**Modification/Change Order No. 5**

Fort Bend County Drainage District

EWP – Oyster Creek Channel Bank Stabilization Phase I

SITE PLAN - 413 AND SECTION VIEW  
OYSTER CREEK - BANK STABILIZATION  
FORT BEND DRAINAGE DISTRICT  
IN  
FORT BEND COUNTY, TEXAS

PLAN VIEW - SITE 413

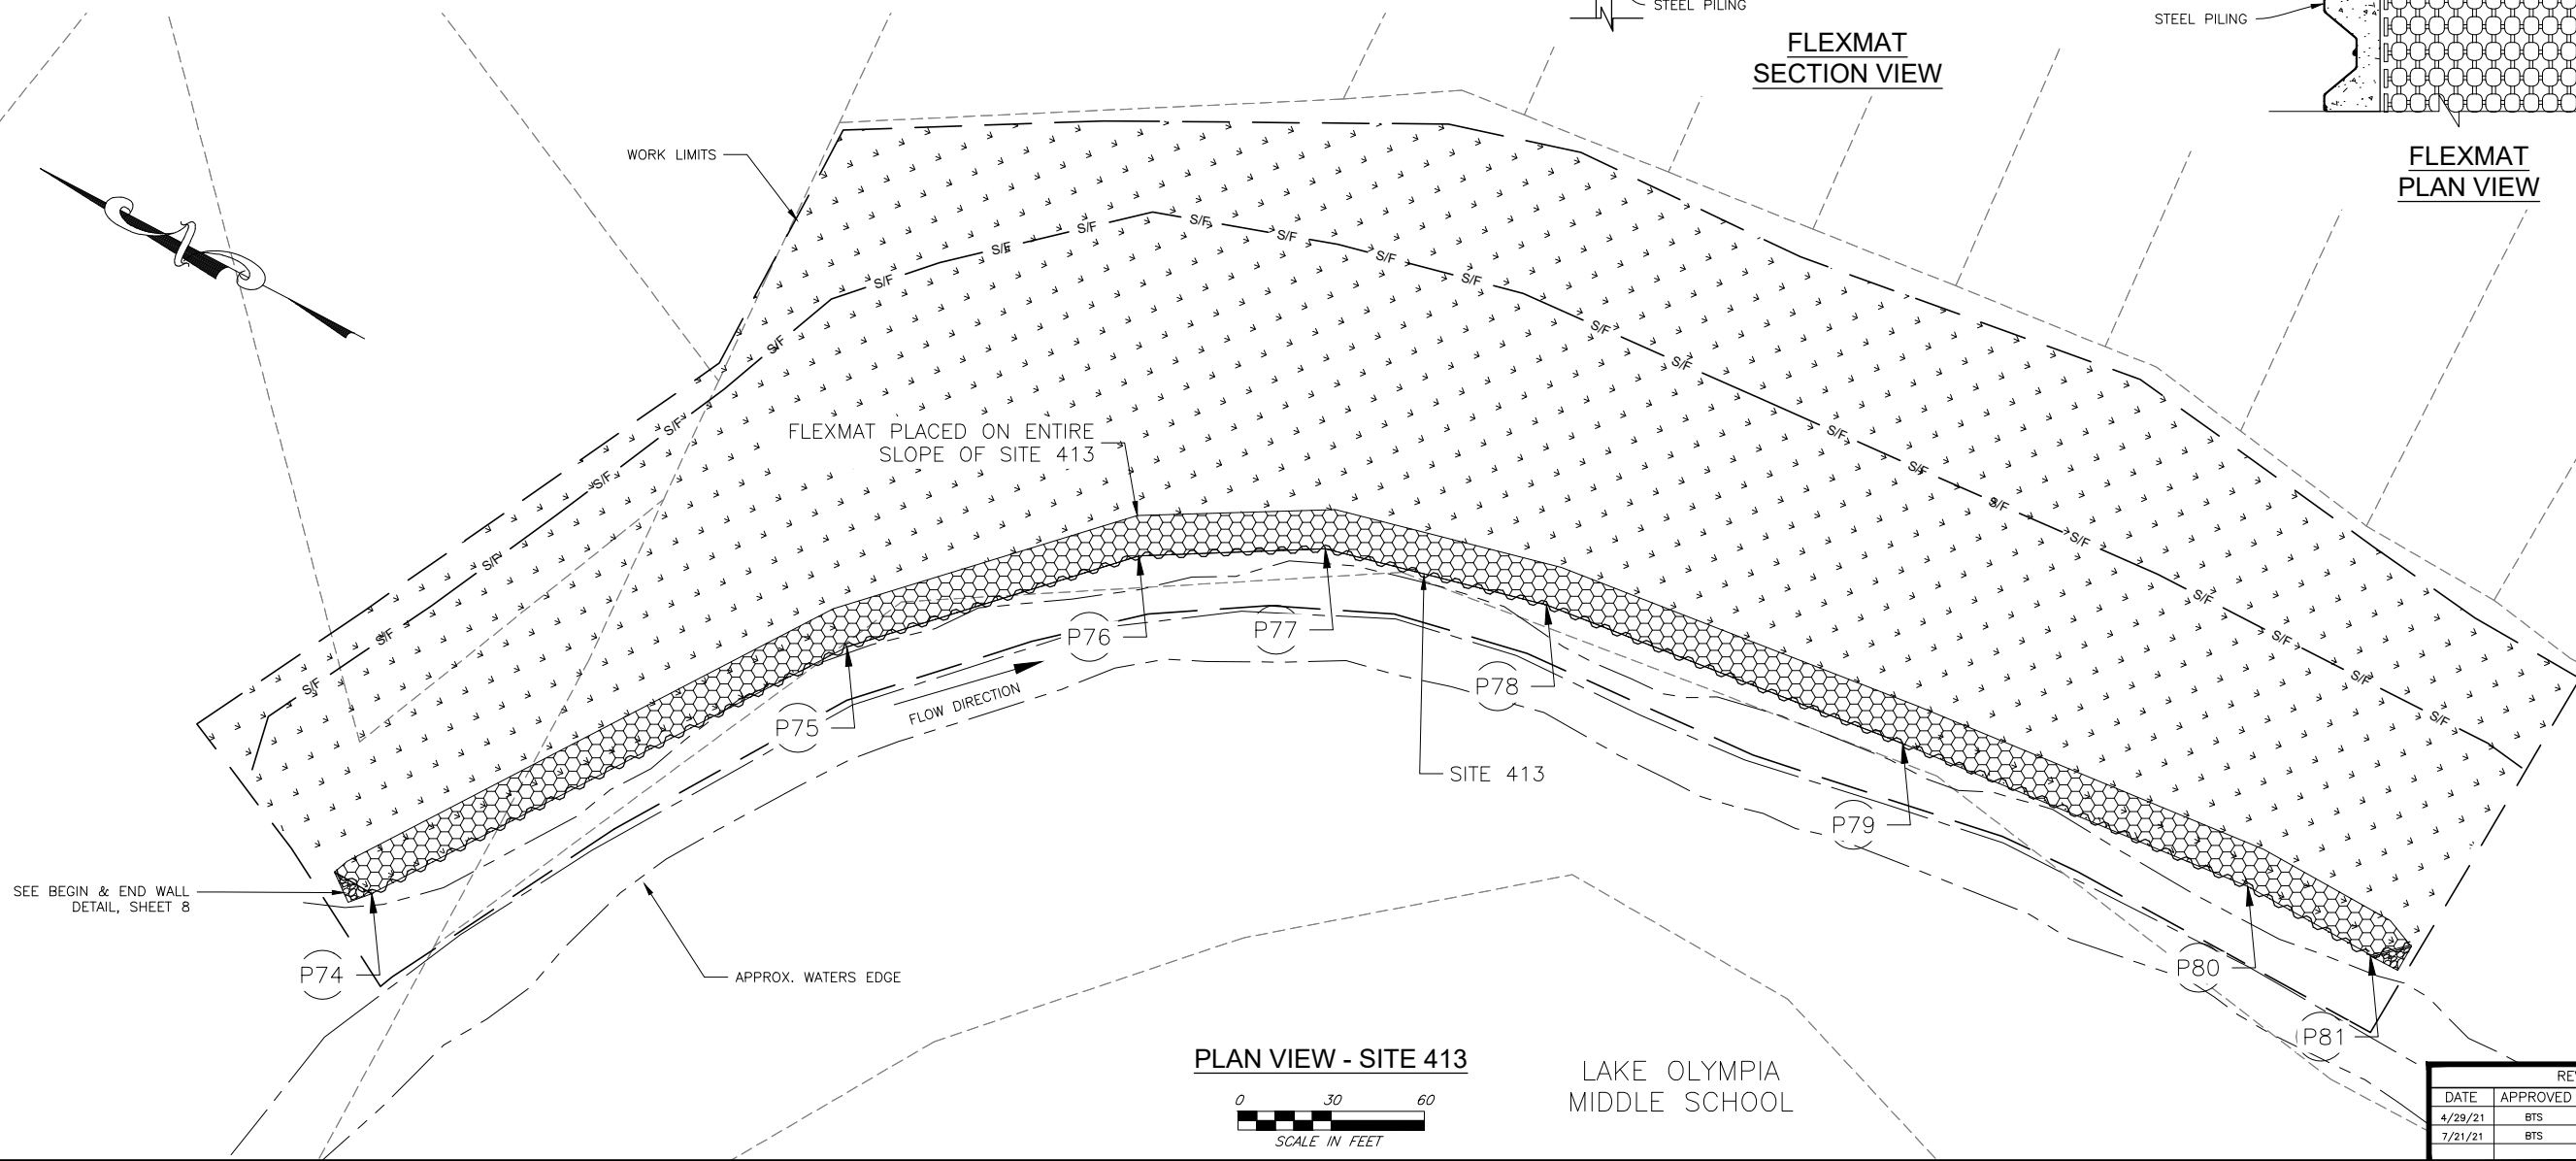
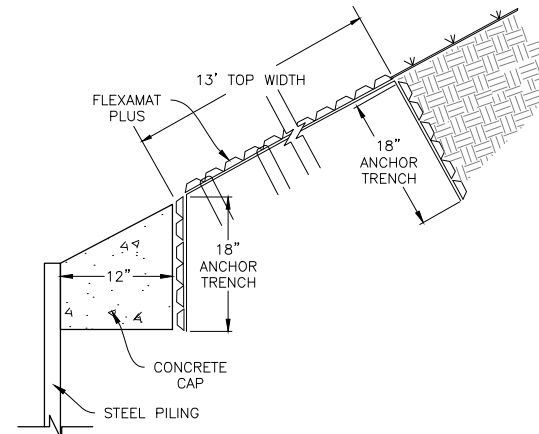
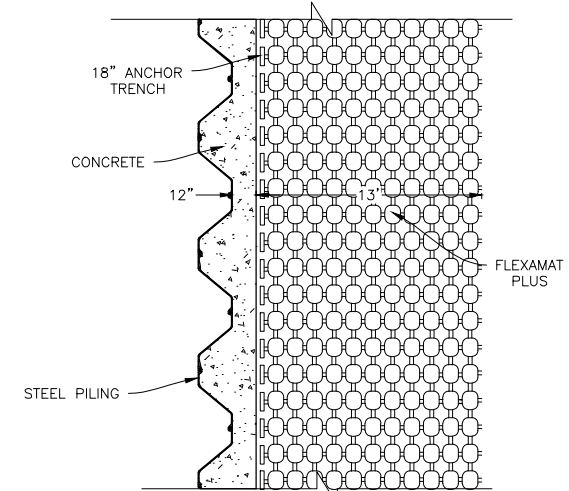
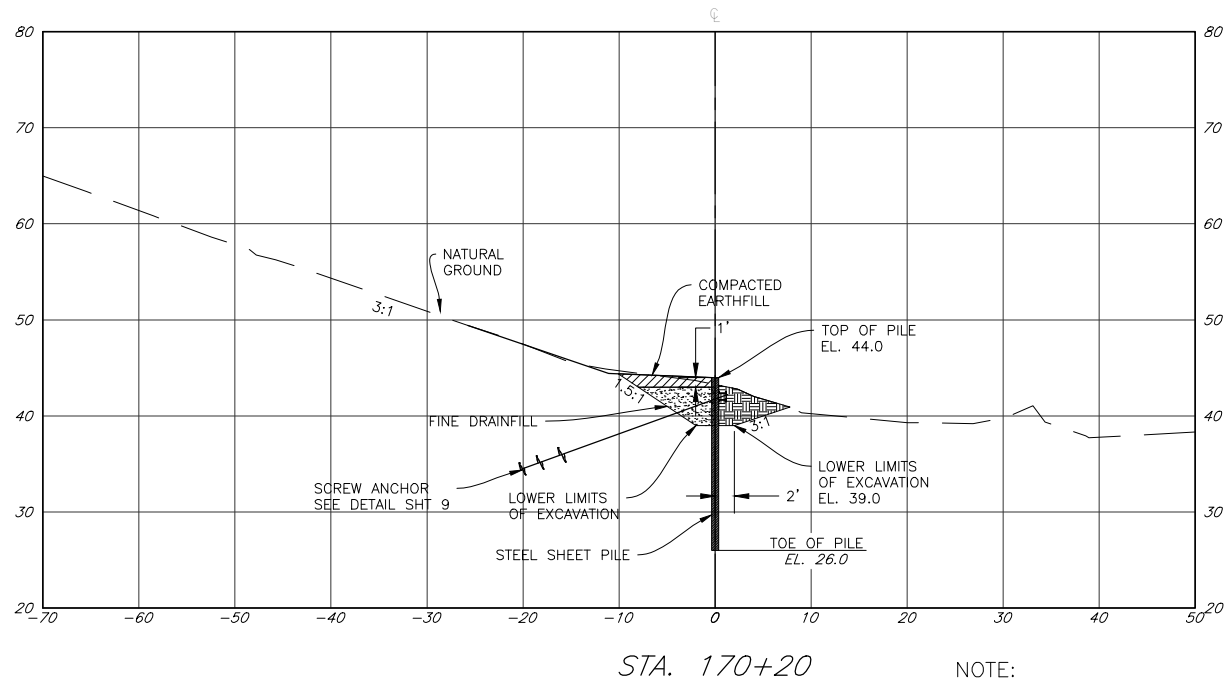
The Contractor shall furnish all labor equipment and material to install flex mat as shown on the attached drawing and specifications at Oyster Creek Phase I Site 413 revised. Measurement and Payment compensation shall be Method 3 in Construction Specification 495, lump Sum.

| REVISIONS |          |                                |
|-----------|----------|--------------------------------|
| 7/21/21   | BTS      | CONCRETE MAT ADDED TO SITE 413 |
